# Authorized Field Change

**AFC G-05909**

**Subject:** Engine Reconfiguration and New Exhaust Emission Label for VT 365 Engines, ESN 0112360 through 141748, with Feature Code 12990 used in Truck Models Built Between February 10, 2004 and September 7, 2004

**Figure 1 Label Position on Right Side Of Engine, 4200 Model, Excludes 1652 Stripped Chassis**

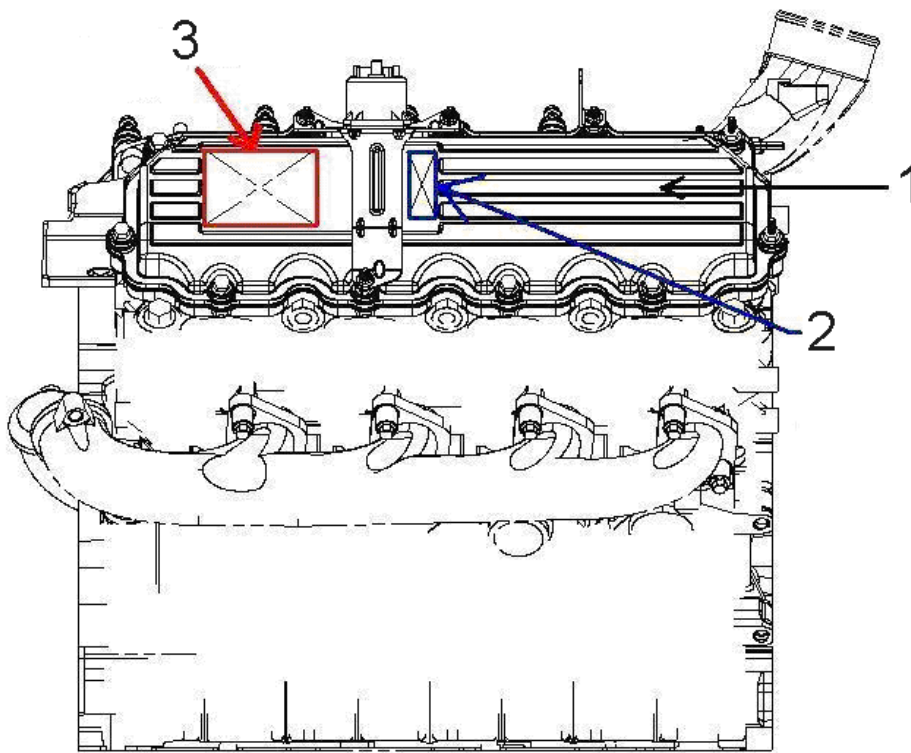
1. Remove and replace the right exhaust tube assembly following the instructions in the VT 365 Engine Service Manual. Tighten the fasteners to specification.
2. Recalibrate to **PRG2PJ52.BIN**.
3. Remove current Exhaust Emission Label and Family Emission Label and install new Exhaust Emission Label. Refer to Figure 1 and Figure 2 for label position depending on the vehicle being serviced.

- A. International LEV 4200 Model, **excluding 1652 Stripped Chassis**, require Exhaust Emission Label 1845354C1 (See Figure 1).
- B. International 1652 Series Stripped Chassis LEV models require Exhaust Emission Label 1855379C1 (See Figure 2).

1. Right Side Valve Cover
2. Family Emission Label (FEL) to be Removed
3. New Exhaust Emission Label Position
